HISTORIC AND DESIGN REVIEW COMMISSION

HDRC CASE NO: 2018-218
ADDRESS: 901 N PINE ST
729 HAYS ST
725 HAYS ST
LEGAL DESCRIPTION:
ZONING: IDZ, H
CITY COUNCIL DIST.: 2
DISTRICT: Dignowity Hill Historic District
APPLICANT: Ricardo Turrubiates/Terramark TX
OWNER: K/T TX Holdings, LLC
TYPE OF WORK: New construction of three, two story residential structures
APPLICATION RECEIVED: April 30, 2018
60-DAY REVIEW: June 29, 2018
REQUEST:

The applicant is requesting a Certificate of Appropriateness for approval to:

OHP SUBMISSION

FLOOR PLAN
LEVEL 2
SCALE: $\frac{1}{4}" = 1'-0"$

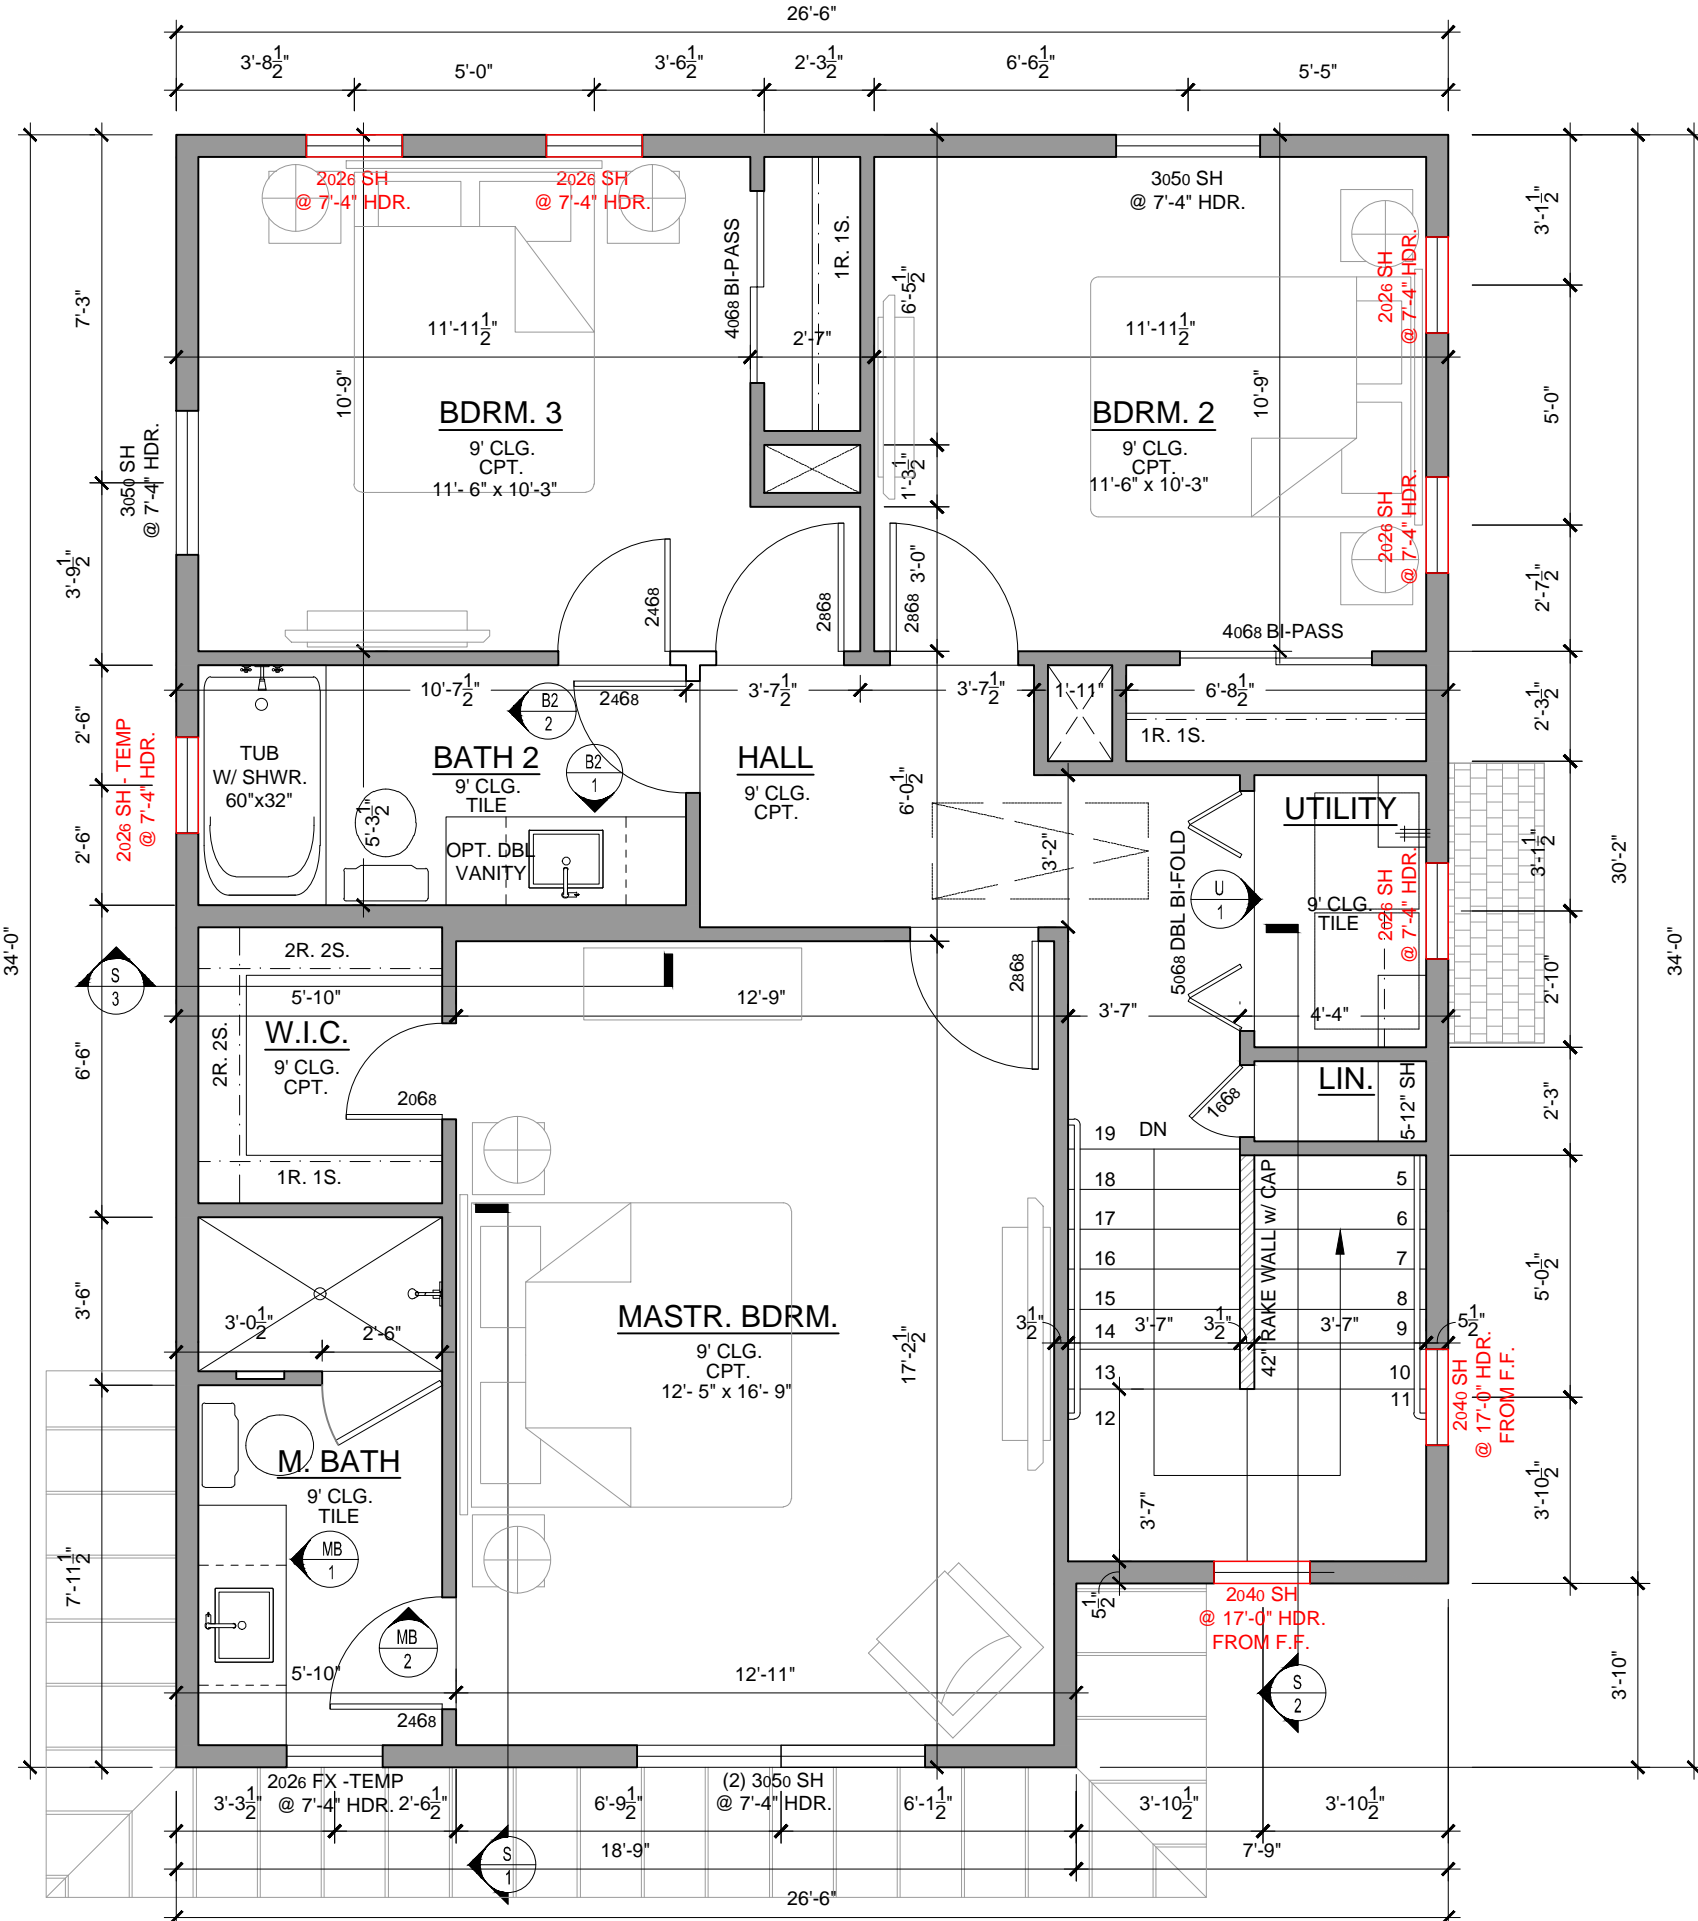
- 3b. SETBACKS & ORIENTATION – According to the Guidelines for New Construction, the front facades of new buildings are to align with front facades of adjacent buildings where a consistent setback has been established along the street frontage. Additionally, the orientation of new construction should be consistent with the historic examples found on the block. The proposed new construction is a corner lot. The applicant has proposed a setback of 34’ – 7”, which is comparable to those found historically on this block of N Pine; however, the side setback proposed on Hays Street is only 25’ – 2”. While this matches the side setback of the historic structure across N Pine, it is less than the front setback of both proposed and existing structures that front Hays. Staff finds this proposed side setback to be inappropriate.

- 3g. WINDOW & DOOR OPENINGS – Per the Guidelines for New Construction 2.C.i., window and door openings with similar proportions of wall to window space as typical with nearby historic facades should be incorporated into new construction. The applicant has modified previously proposed window openings to include a full sash windows on each façade rather than a combination of fixed and sash windows. Staff finds the proposed windows to be appropriate and consistent with the Guidelines. Staff finds that the applicant should explore the installation of a window to the right of the front door.

3. Staff recommends approval of item #3 based on findings 3a through 3n with the following stipulations:
 - i. That the applicant explore the installation of a window to the right of the front door as noted in finding 2g.

LEFT
ELEVATION
SCALE: $\frac{1}{4}" = 1'-0"$

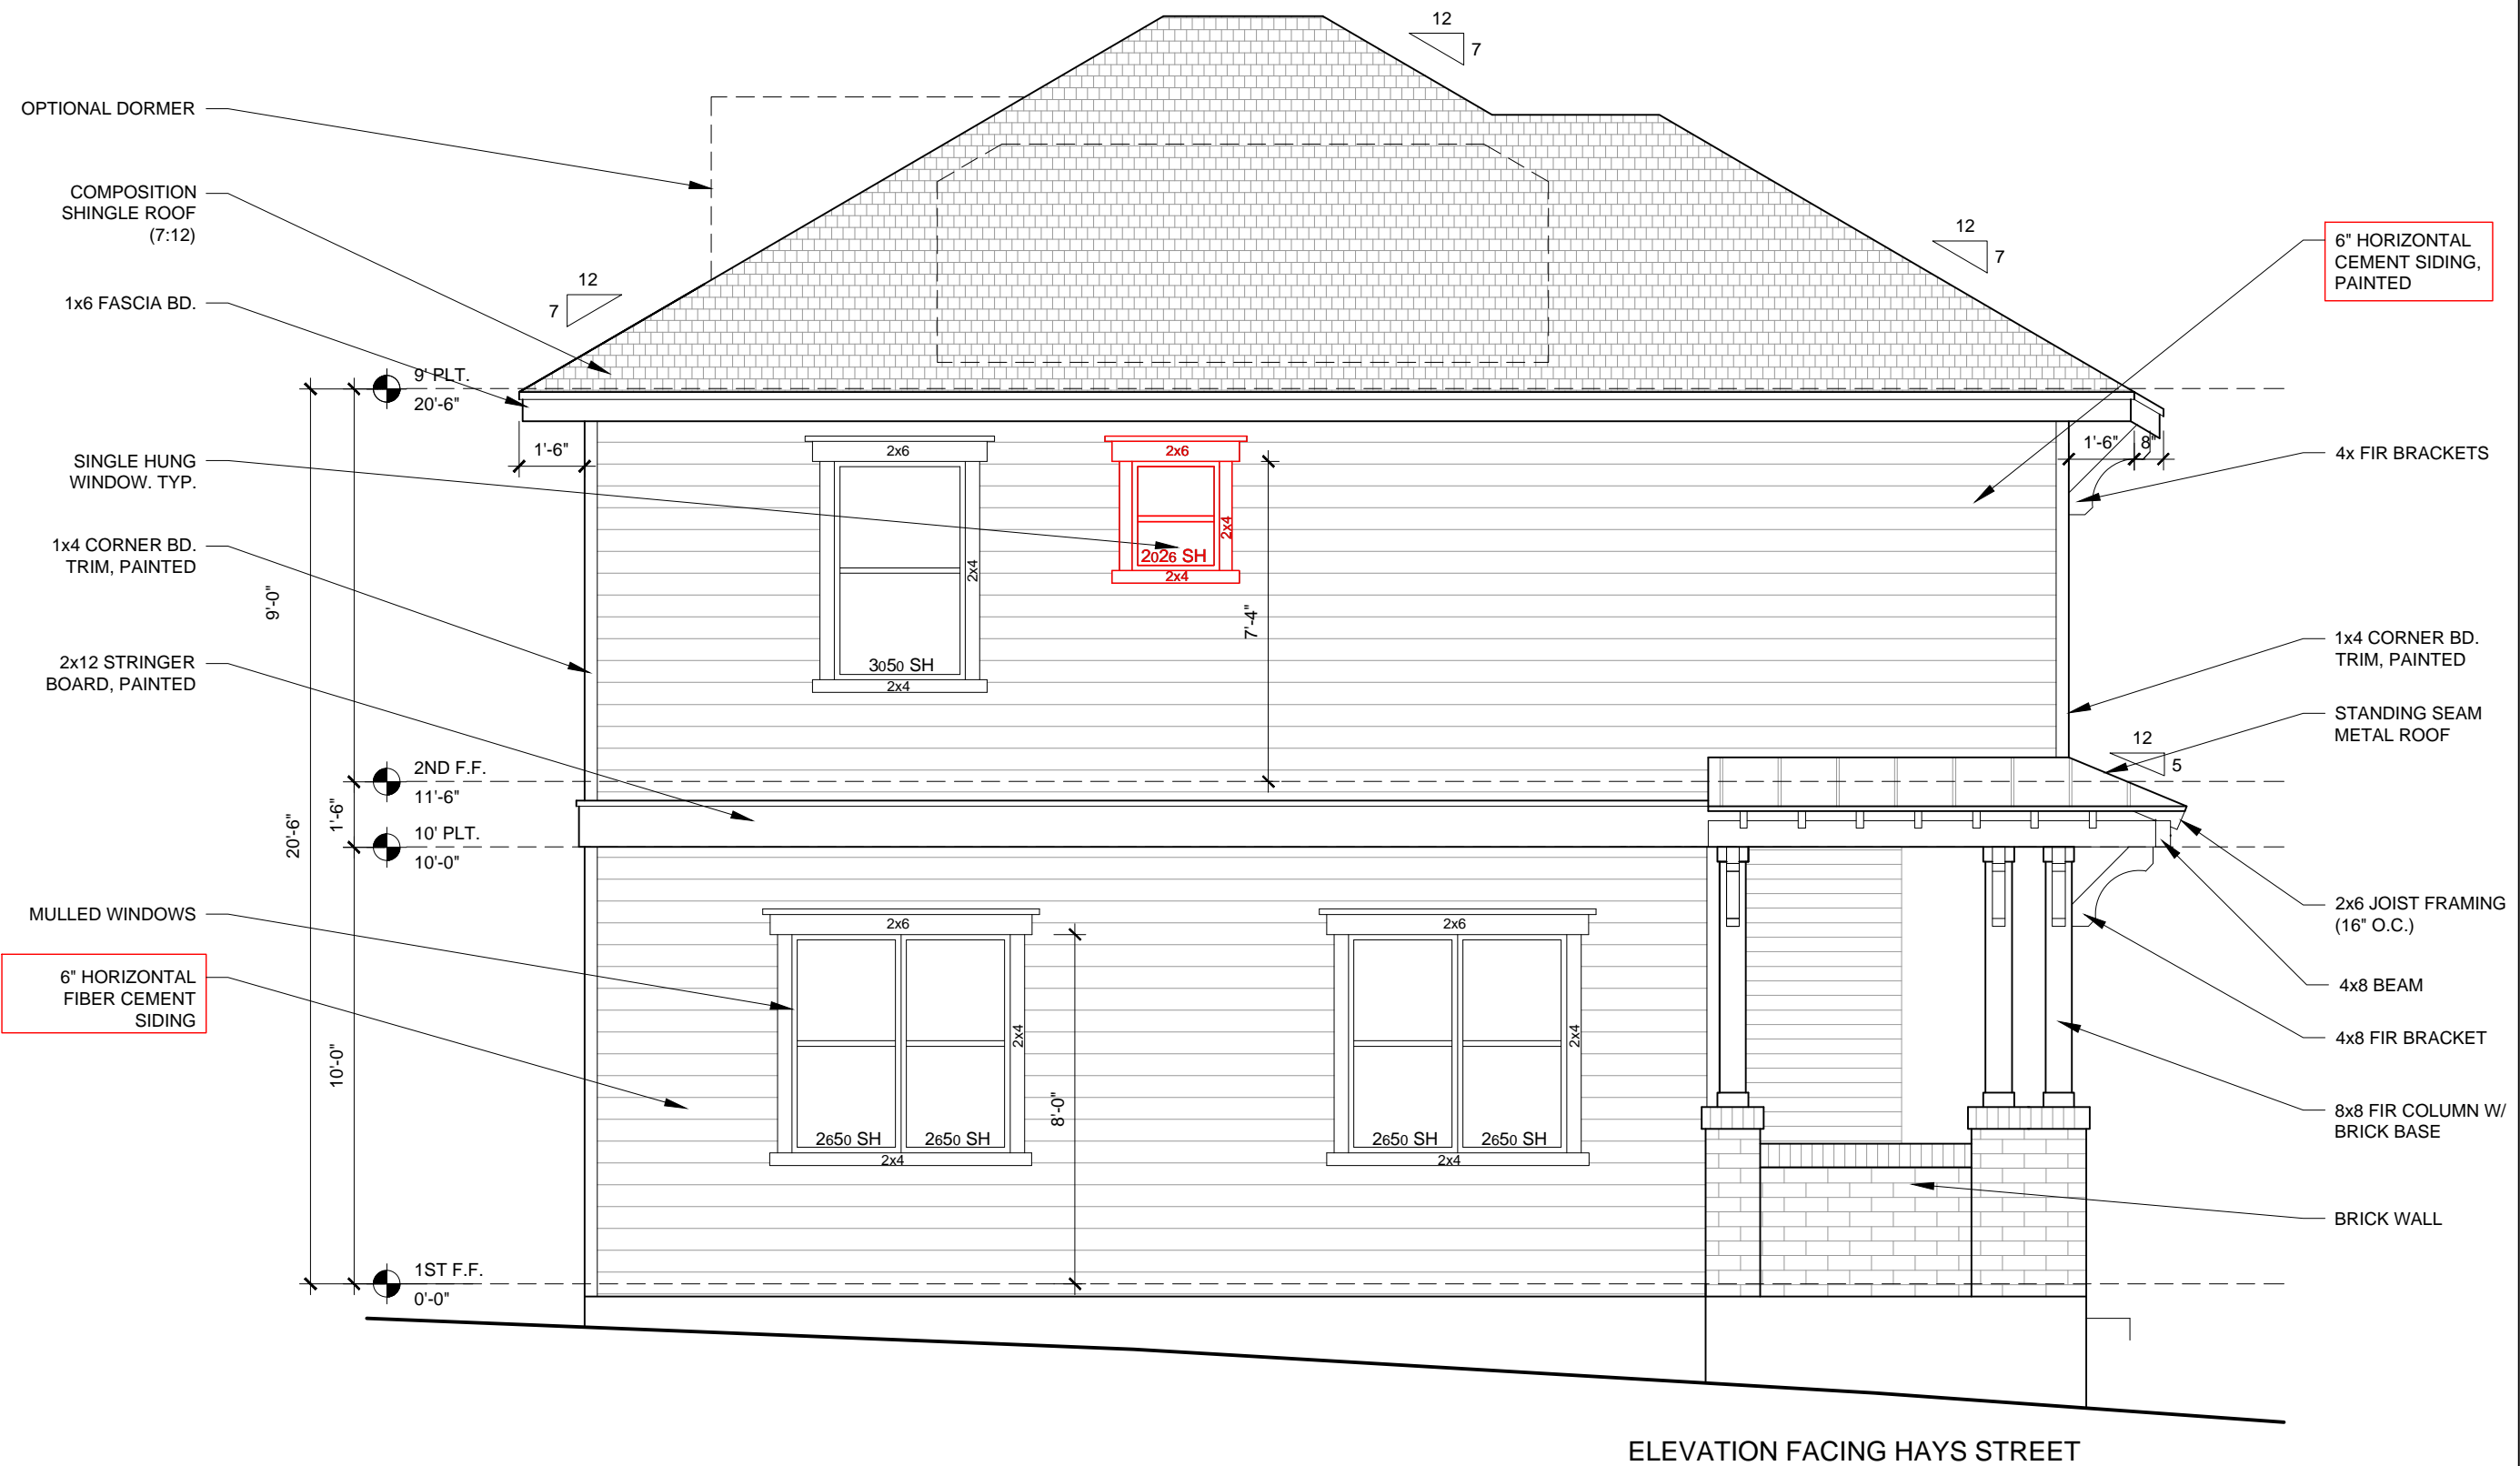
- 3f. ROOF FORM –The applicant has proposed a roof form to include a hipped roof with a a rear roof form that features a half hipped, half gabled roof. At the rear, the applicant has proposed a compound roof to feature both a dipped and gabled roof, resulting in an increased roof height from what is featured on the front of the structure. Staff finds that the rear roof form should either feature a hip or gable that has a height consistent with that found on the front of the structure. This would also match roof forms found historically on the block.

has proposed brick and wood columns. Generally staff finds the proposed porch depth and column design appropriate; however, staff finds that a full width porch would be most appropriate to relate to the historic, two story Craftsman houses in the immediate vicinity.

- iv. That all double windows are separated by mullions featuring at least six inches in width as noted in finding 2m.
- v. That the proposed concrete driveway does not exceed ten (10) feet in width as noted in finding 2n.
- vi. That the side setback on Hays Street be increased as noted in finding 3b.
- vii. That the current roof form be modified to more closely relate to the design updates found on the request items noted in #1 and #2 as noted in finding 3f.

D.4 WINDOW TRIM DETAIL

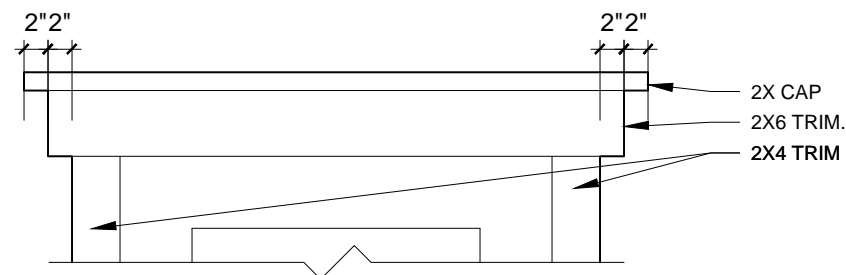
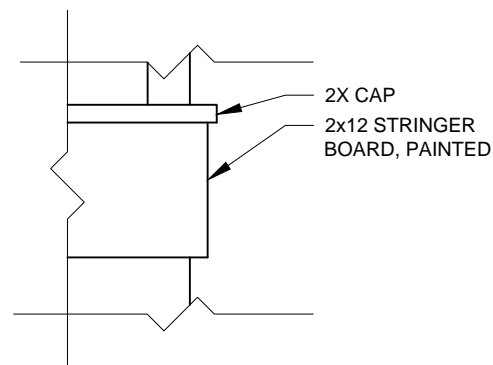
- 1j. **WINDOW MATERIALS** – The applicant has proposed vinyl windows to feature a minimum of two inches in depth between the front face of the window trim and the front face of the top window sash. Staff finds the proposed window material to be inconsistent with the Guidelines. Per the Guidelines, an aluminum-clad wood window is most appropriate in terms of depth and appearance. Window trim must feature traditional dimensions and an architecturally appropriate sill detail. Window track components must be painted to match the window trim or concealed by a wood window screen set within the opening.

- 1k. **WINDOW TRIM** – The applicant has noted the installation of window trim to include 2x4 and 2x6 dimensional lumber. This trim detail has been used by the applicant previously.

- 2j. WINDOW MATERIALS – The applicant has proposed vinyl windows to feature a minimum of two inches in depth between the front face of the window trim and the front face of the top window sash. Staff finds the proposed window material to be inconsistent with the Guidelines. Per the Guidelines, an aluminum-clad wood window is most appropriate in terms of depth and appearance. Window trim must feature traditional dimensions and an architecturally appropriate sill detail. Window track components must be painted to match the window trim or concealed by a wood window screen set within the opening. WINDOW TRIM – The applicant has noted the installation of window trim to include 2x4 and 2x6 dimensional lumber. This trim detail has been used by the applicant previously.

- 3j. WINDOW MATERIALS – The applicant has proposed vinyl windows to feature a minimum of two inches in depth between the front face of the window trim and the front face of the top window sash. Staff finds the proposed window material to be inconsistent with the Guidelines. Per the Guidelines, an aluminum-clad wood window is most appropriate in terms of depth and appearance. Window trim must feature traditional dimensions and an architecturally appropriate sill detail. Window track components must be painted to match the window trim or concealed by a wood window screen set within the opening.

- 3k. WINDOW TRIM – The applicant has noted the installation of window trim to include 2x4 and 2x6 dimensional lumber. This trim detail has been used by the applicant previously.

- iii. That the proposed windows be aluminum-clad wood windows and follow staff's specifications. White manufacturer's color is not allowed, and color selection must be presented to staff. There should be a minimum of two inches in depth between the front face of the window trim and the front face of the top window sash. This must be accomplished by recessing the window sufficiently within the opening or with the installation of additional window trim to add thickness. Window trim must feature traditional dimensions and an architecturally appropriate sill detail. Window track components must be painted to match the window trim or concealed by a wood window screen set within the opening.

- iii. That the proposed windows be aluminum-clad wood windows and follow staff's specifications. White manufacturer's color is not allowed, and color selection must be presented to staff. There should be a minimum of two inches in depth between the front face of the window trim and the front face of the top window sash. This must be accomplished by recessing the window sufficiently within the opening or with the installation of additional window trim to add thickness. Window trim must feature traditional dimensions and an architecturally appropriate sill detail. Window track components must be painted to match the window trim or concealed by a wood window screen set within the opening.

minimum of two inches in depth between the front face of the window trim and the front face of the top window sash. This must be accomplished by recessing the window sufficiently within the opening or with the installation of additional window trim to add thickness. Window trim must feature traditional dimensions and an architecturally appropriate sill detail. Window track components must be painted to match the window trim or concealed by a wood window screen set within the opening.
